## 20 LOCAL AGENCY COMMENTS

# Submission 1173 (Greg Nudd, Bay Area Air Quality Management District, September 23, 2020)

Re: California High-Speed Rail Authority San Francisco to San Jose Project Section Draft EIR/EIS

Figure Metis-4

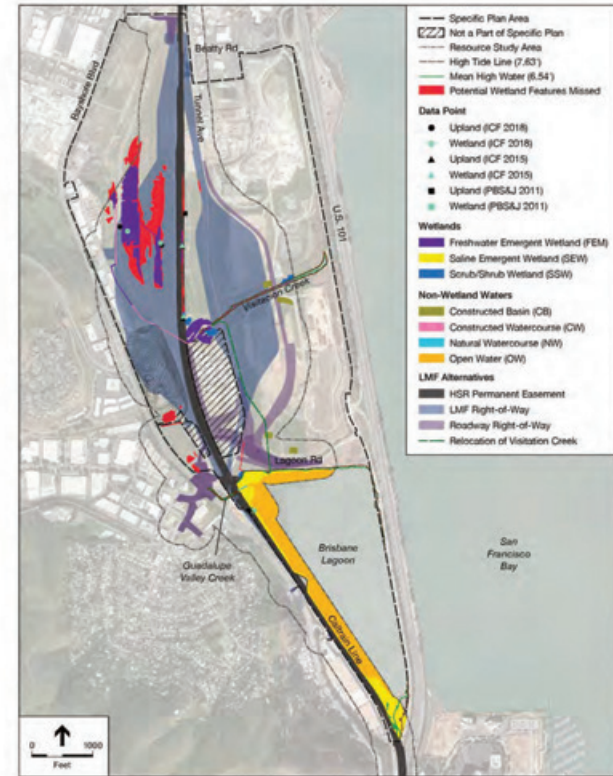
With the exception of a preliminary jurisdictional delineation for wetlands, the discussion of existing biological resources that would be affected by the Brisbane LMF is largely based on data gathered during preparation of a 2013 Program EIR addressing development of the Brisbane Baylands that was not intended for use in a project-level environmental document. Because the 2013 Baylands Program EIR, covering much of the same footprint as the proposed LMF, recognized that surveys and baseline data were prepared during a period of severe drought, the Final Program EIR included a requirement for updated site-specific surveys to be undertaken prior to approval of development of the Baylands area within which the West and East LMF sites are proposed.

Consistent with the City of Brisbane’s Baylands Program EIR’s requirements, Metis Environmental Group biologists conducted a series of surveys in the Brisbane Baylands in 2019 and 2020 in anticipation of updating the baseline habitat maps that were previously presented in the 2013 Program EIR for the Brisbane Baylands. During this survey effort, Metis biologists noted that in the years since the 2013 Program EIR’s initial biological resources analyses, wetland habitats and special status plant habitats have expanded in overall area and exhibit improved quality since the 2013 Program EIR was released owing to increased rainfall in subsequent years. This fact has not been noted in the Draft EIR/EIS primarily because the survey efforts within the LMF were insufficient and the desktop analysis and habitat modeling did not adequately capture existing conditions on the LMF’s 100+ acre area of impact. Consequently, the EIR/EIS presents a baseline and analysis that understate the extent of wetlands, diversity of sensitive plant populations in grassland habitats on Icehouse Hill, and fails to identify and address significant impacts to sensitive plants within the LMF that were not previously identified in documents the EIR/EIS uses to establish its baseline. Figure Metis-3 depicts the habitats on Icehouse Hill, within the West LMF footprint that were not identified including Coast Iris (*Iris longipetala*), seasonal wetland and drainage habitat, and Arroyo Willow thickets. These resources would be destroyed as a result of grading and removal of Icehouse Hill for the West LMF and need to be acknowledged in the Draft EIR/EIS as significant impacts.

Figure Metis-11

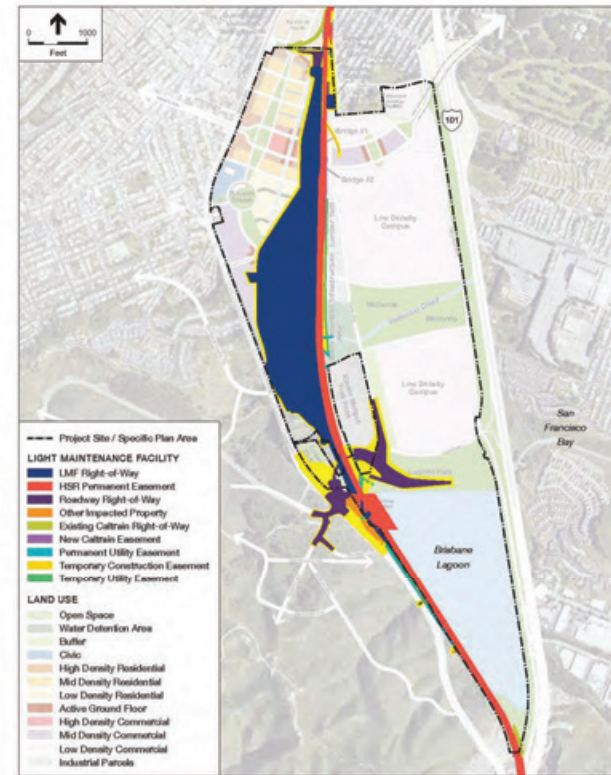
The loss of the site's primary open space and recreational amenities would jeopardize the ability for Baylands development to provide the required 25% of land area to be devoted to open space and open areas without a substantial loss of development capacity in addition to the development lost to the LMF itself. Because of the commitment made by the City to State legislators that 1,800 to 2,200 dwelling units would be permitted within the Baylands, reduction of the site's development capacity would likely be achieved by reducing the amount of commercial/office use within the Baylands that could, in turn, jeopardize the ability of Baylands development to pay for itself by generating sufficient revenue to the City to pay for the costs of City services to be Baylands "during all phases of development and upon final buildout."

**Figure EKI-1**  
East Brisbane Light Maintenance Facility  
Brisbane Landfill Location

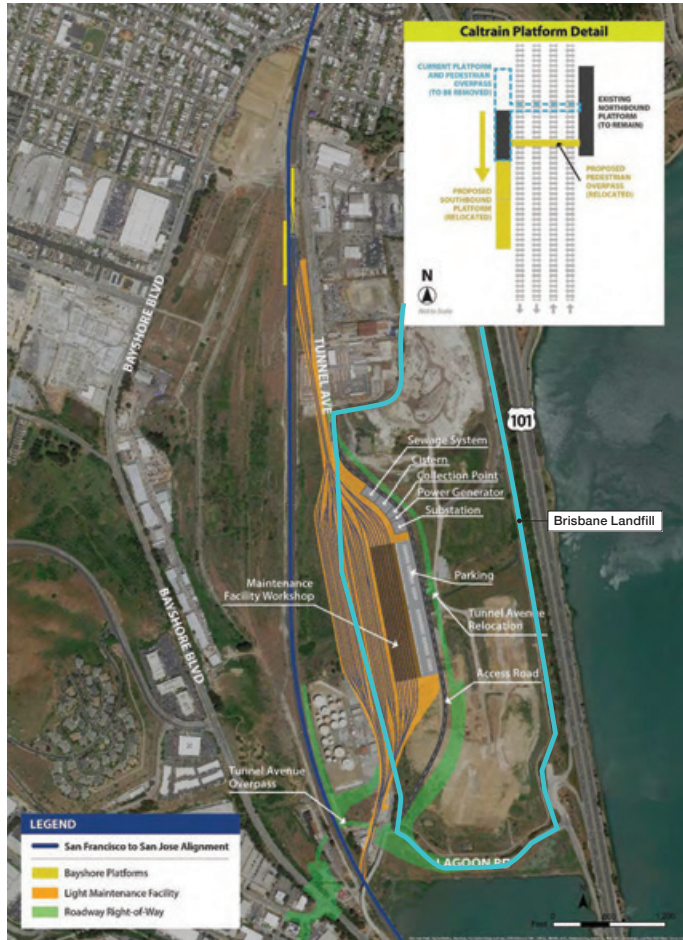
Approximately 75% of the East Brisbane LMF footprint is located within the footprint of the landfill (Figure EKI-1). The current elevation of the landfill is highly variable, but on average is approximately at an elevation of 40 feet and the current Caltrain track alignment are approximately at an elevation of 15 feet. Thus, excavation of the East Brisbane LMF to track grade, not accounting for any over-excavation to install a landfill cap or to reach the project subgrade, would result in the generation of approximately 3,000,000 cy (75 acres with an average cut of 25 feet), approximately 50% more than that estimated in the Draft EIR. This quantity of soil equates to approximately 250,000 truckloads of material. The air quality assessment in Section 3.3 should account for these quantities of transportation and off-site disposal. Moreover, the project costs do not appear to account for the fact that the characterization of the landfill contents is not known and soil disposal costs are not included; at a minimum the material would likely have to be disposed of at a Class II landfill but some will likely require disposal at a Class I hazardous waste landfill.

Figure 2-32 illustrates the East Brisbane LMF layout atop aerial imagery; the relationship between the former Brisbane landfill and the East Brisbane LMF is visible in this figure. Additionally, Book A4, sheets 67 and 68 of Volume 3, Preliminary Engineering Plans, show the LMF configuration and profiles indicating the original ground surface in the vicinity of the East Brisbane LMF in relation to the proposed track elevations. The comment did not result in any revisions to the Draft EIR/EIS.

The comment notes that a west-facing slope would be required adjacent to the former landfill under Alternative A. Refer to Book A4, sheet 68 of Volume 3, Preliminary Engineering Plans, for a cross section of the East Brisbane LMF, which shows the profile of the proposed project features in relation to the original ground surface elevation. A 1:3.5 slope gradient (28.6 percent) is proposed east of the relocated Tunnel Avenue and is within an area of the project footprint identified as TCE. The comment did not result in any revisions to the Draft EIR/EIS.

The comment asserts that the Draft EIR/EIS does not address slope stability of the new west-facing slope at the interface of the East Brisbane LMF and the remaining portions of the former landfill. Refer to Book A4, sheet 68 of Volume 3, Preliminary Engineering Plans, for a cross section of the East Brisbane LMF, which shows the profile of the proposed project features in relation to the original ground surface elevation. A 1:3.5 slope gradient (28.6 percent) is proposed east of the relocated Tunnel Avenue. Consistent with Title 27 requirements, the integrity of the slope would be designed and maintained to protect public health and safety. To address this comment, additional information about Title 27 requirements for slope stability has been added to Section 3.9.2.1, Geology, Soils, and Seismicity, and Impact GEO#6 in the Final EIR/EIS.
